**RESPONSE TO COMMENTS DATED NOVEMBER 1, 2016 FOR:
Arkins Park Quarries; DRMS File No. M-1985-212; Adequacy Review No. 1 (AM03)**

CORRECTIVE ACTION – RECONFIGURE PERMIT BOUNDARY VIA
AMENDMENT PROCESS TO CORRECT VIOLATION OF AFFECTED
LANDS OUTSIDE OF APPROVED PERMIT BOUNDARY

Permit: M-1985-212 Amendment Application
Prepared by: Coffey Engineering & Surveying

EXHIBIT C.1

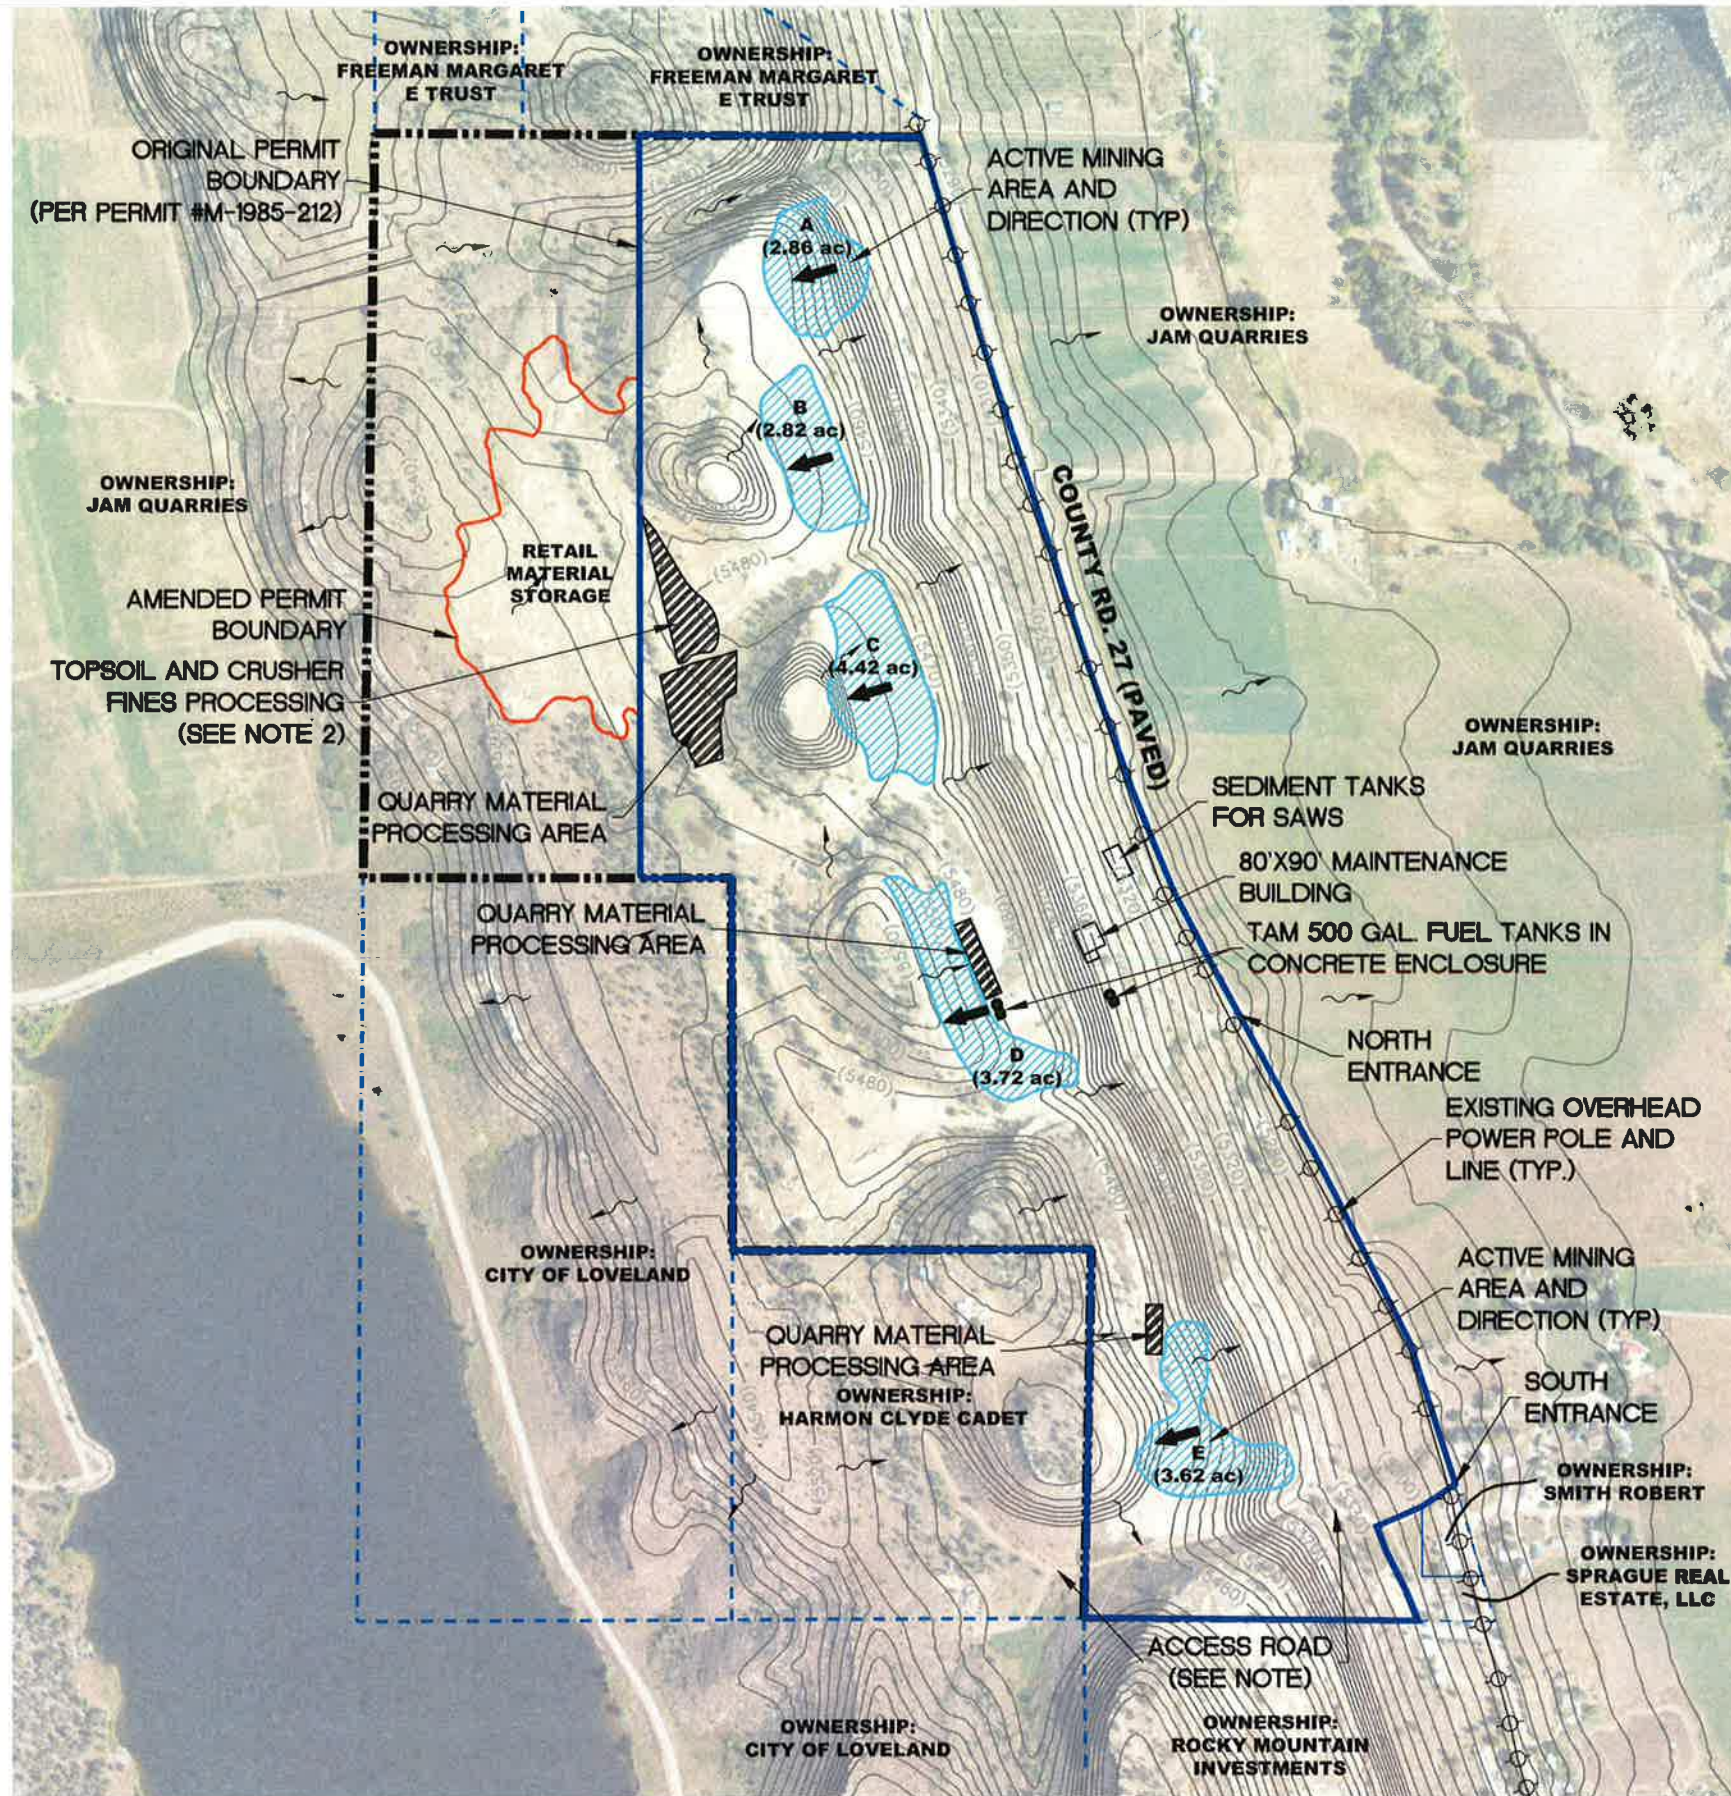
3. As required by Rule 6.2.1(2)(e), the acceptable range of map scales shall not be larger than 1 inch = 50 feet nor smaller than 1 inch = 660 feet. The map scale of Exhibit C.1 is at 1 inch = 800 feet. Please revise the scale of Exhibit C.1 to match the acceptable range of map scales.

4. As required by Rule 6.4.3(b), the Mining Plan Map must show power and communication lines on the area of affected land and within 200 feet of all boundaries of such area. Please revise Exhibit C.1 to include the overhead powerlines along County Road 27.

5. As required by Rule 6.4.3(c), the Mining Plan Map must show the existing topography of the area with contour lines of sufficient detail to portray the direction and rate of slope. Please revise Exhibit C.1 to include contour lines.

6. As required by Rule 6.4.3(e), the Mining Plan Map must show the type of vegetation covering the affected lands. Please revise Exhibit C.1 to show the type of vegetation covering the affected lands. This information may be portrayed by adding a note to the Mining Plan Map which describes the existing vegetation.

RESPONSE: The scale for C.1 has been revised to 1" = 660'.

RESPONSE: The powerlines along CR 27 have been added.

RESPONSE: Existing topography (10' intervals) has been added to the map.

RESPONSE: A note has been added to the map (as well as F.1).

EXHIBIT F.1 RECLAMATION PLAN MAP

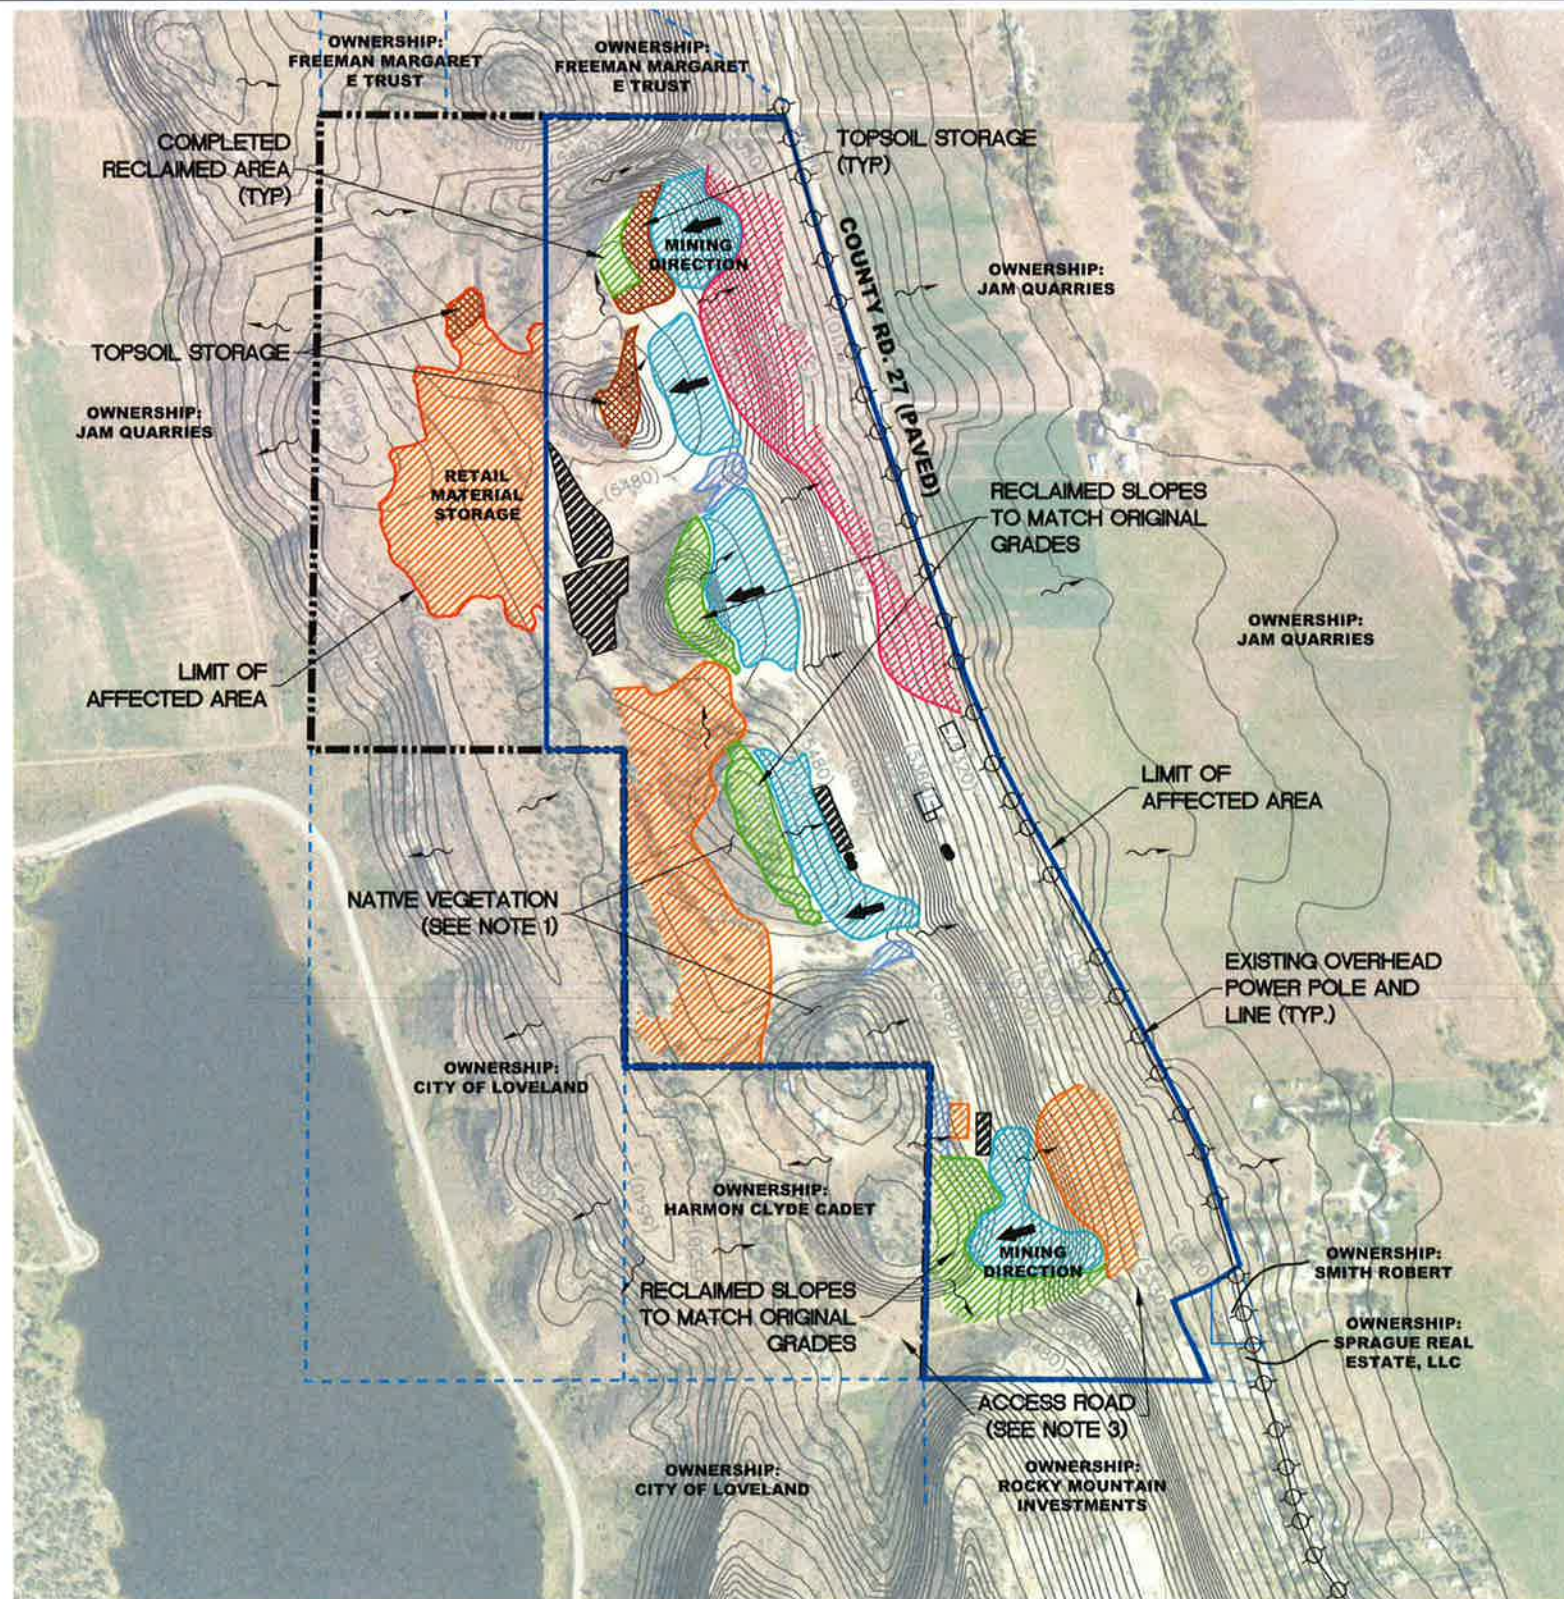
9. The Reclamation Plan Map states the disturbed areas encompass 139.1 acres. In addition, the map provides acreages for the individual types of disturbances (mining, topsoil storage, material storage, future mining, reclamation started, reclamation completed). The individual acreages do not add up to 139.1 acres. Please provide an accounting of the types of disturbance that make up the 139.1 acres of disturbed/affected land.

23. As required by Rule 6.4.6(a), the Reclamation Plan Map must show the proposed topography of the site with contour lines of sufficient detail to portray the direction and rate of slope of all reclaimed lands. Please revise the Reclamation Plan Map to include contour lines which show the proposed topography of all reclaimed areas.

RESPONSE: A note has been added to the map regarding the acreages. The reference to 139.1 acres has been removed. The total affected area is 192.4 acres (amended permit boundary).

RESPONSE: The existing topography is shown on the map and a note is included to match slopes upon reclamation.
